STAFF RECOMMENDATION
2200 Grantland Avenue
February 15, 2017

Application: New construction- infill
District: Woodland in Waverly Historic Preservation Zoning Overlay
Council District: 17
Map and Parcel Number: 10514010500
Applicant: Brittney Mount, Allard Ward Architects
Project Lead: Paul Hoffman, paul.hoffman@nashville.gov

<p>Description of Project: The applicant proposes new construction of a residence on this vacant lot.</p> <p>Recommendation Summary: Staff recommends approval with the conditions:</p> <ol style="list-style-type: none">1. The finished floor height shall be consistent with the finished floor heights of adjacent historic houses, to be verified by MHZC staff in the field;2. Double and triple windows have a four to six inch (4"-6") mullion between them;3. Staff approve the final details, dimensions and materials of windows and doors prior to purchase and installation;4. The HVAC shall be located behind the house or on the right side, beyond the mid-point of the house;5. Staff approve the roof color and masonry color, dimensions and texture;6. Any appurtenances, including fences and other permanent landscape features, shall be approved by MHZC prior to purchase and

Site Layout Plan

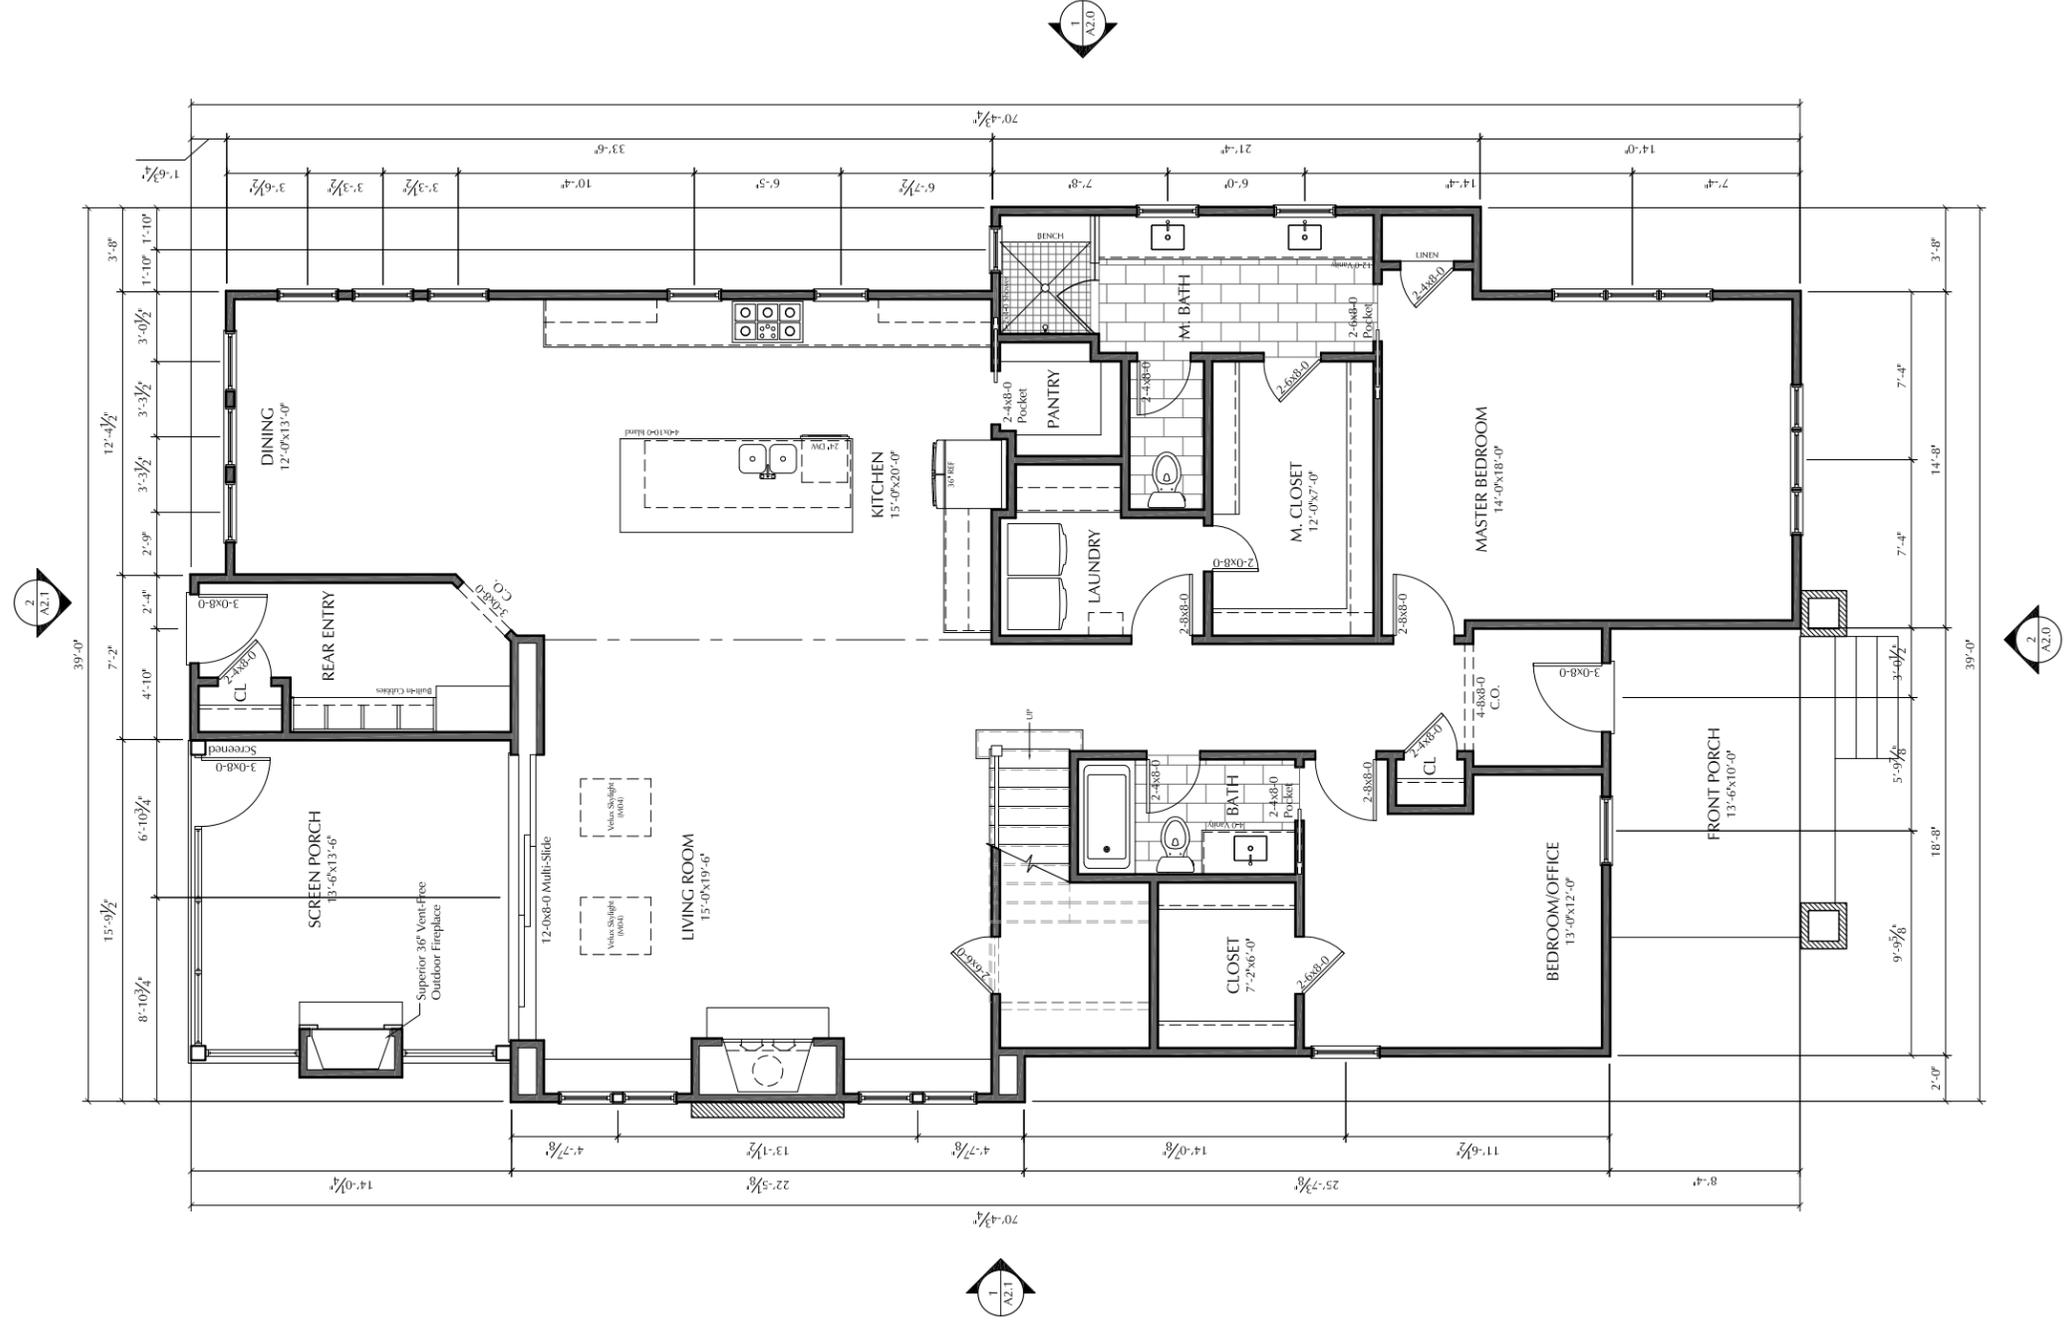
Setback and Rhythm of Spacing: The proposed structure meets the minimum setback requirements by base zoning. The structure will be approximately twenty feet (20') from the left side (street-side) of the property and five feet (5') from the right side property line, and it will be approximately sixty-eight feet (68') from the rear property line. The front edge of the building will be located twenty-six feet (26') from the front property line, which matches that of the adjacent historic building. The project meets section III.B.2.c.

Appurtenances: The new building will have a walkway from the front porch to Grantland Avenue and a concrete driveway/parking pad accessed from the rear alley. Fences and other landscape features were not indicated. If other site features are proposed, staff recommends having approval of them prior to their installation. The location of the HVAC and other utilities was not noted. Staff recommends as a condition of approval that the HVAC be located on the rear façade, or on the non-street facing side beyond the midpoint of the house. With these conditions, the project meets section III.B.i.

A2.0

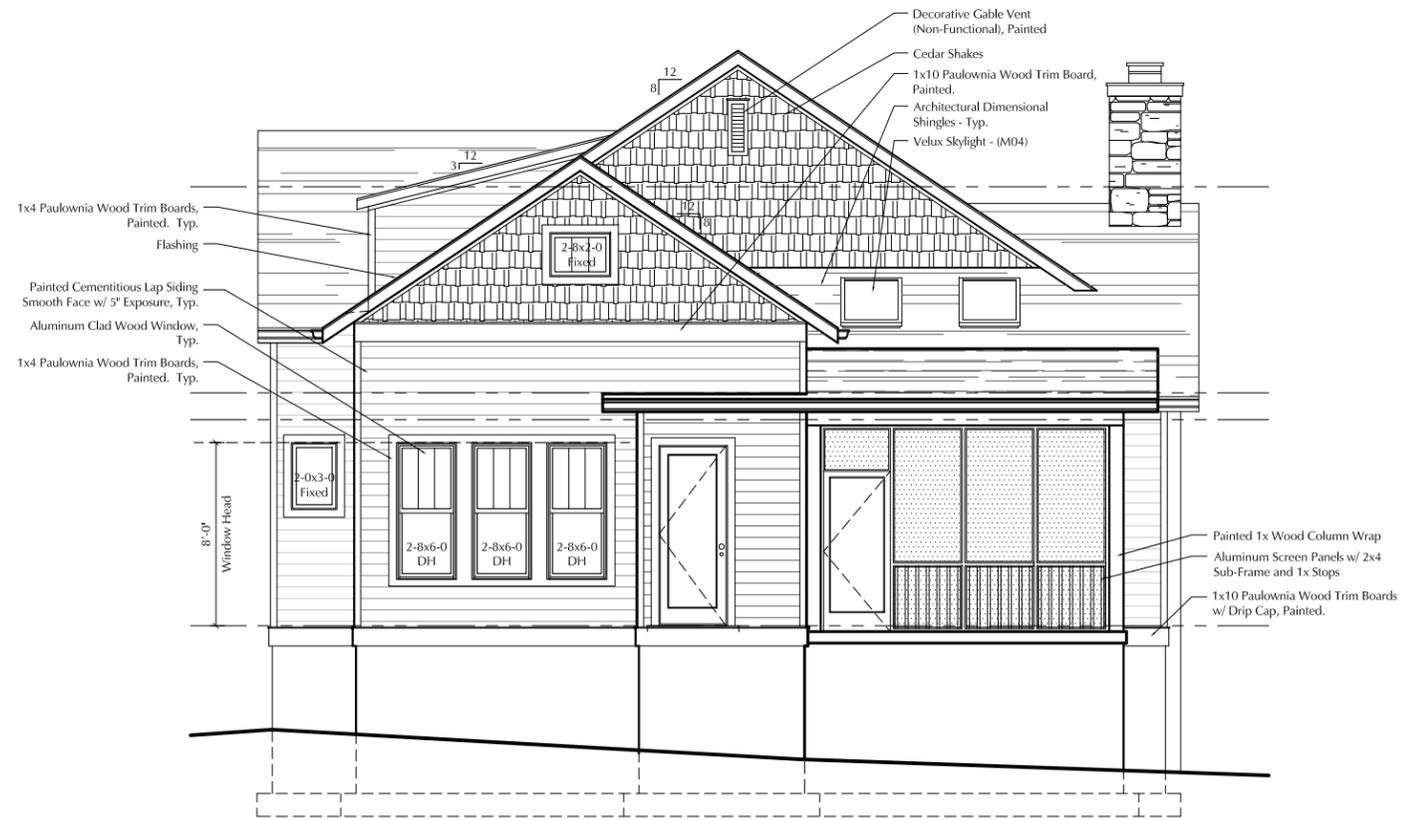
Height and Scale: The proposed infill will be one and one-half story with a ridge height of twenty-seven feet (27') from grade. The eave height is twelve feet (12') from the finished floor height. The foundation height is two feet (2') on the right side, increasing to three feet (3') on the left side, due to cross slope on the lot. Contributing buildings on this block of Grantland Avenue range between nineteen feet (19') and twenty-nine feet

Roof Form: The new structure has a front-facing gable with a side-gabled bay on each side. The primary roof pitch is 8/12. Shed-roofed dormers are on both sides of the building. An exterior chimney is on the building’s left side. Staff finds that the proposed roof form does not contrast greatly with surrounding structures, and the project meets section III.B.2.e.

Proportion and Rhythm of Openings: The new structure’s windows are generally twice as tall as they are wide, meeting the historic proportion of window openings. The largest expanse of wall space without an opening is twelve feet (12’) on the left side. The building’s right side features a pair of horizontally-oriented windows. Similar square windows are found on historic buildings when flanking a chimney; this location will be approximately ten feet from the neighboring building. Due to the minimal visibility, staff finds them acceptable here. The triple windows on the front and right side were drawn without mullions between them; staff recommends that all double and triple windows have four to six inch (4”-6”) mullions between them. Staff finds the project’s proportion and rhythm of openings to meet Section III.B.2.g.

1. The finished floor height shall be consistent with the finished floor heights of adjacent historic houses, to be verified by MHZC staff in the field;
2. Double and triple windows have a four to six inch (4"-6") mullion between them;
3. Staff approve the final details, dimensions and materials of windows and doors prior to purchase and installation;
4. The HVAC shall be located behind the house or on the right side, beyond the mid-point of the house;
5. Staff approve the roof color and masonry color, dimensions and texture;
6. Any appurtenances, including fences and other permanent landscape features, shall be approved by MHZC prior to purchase and installation.
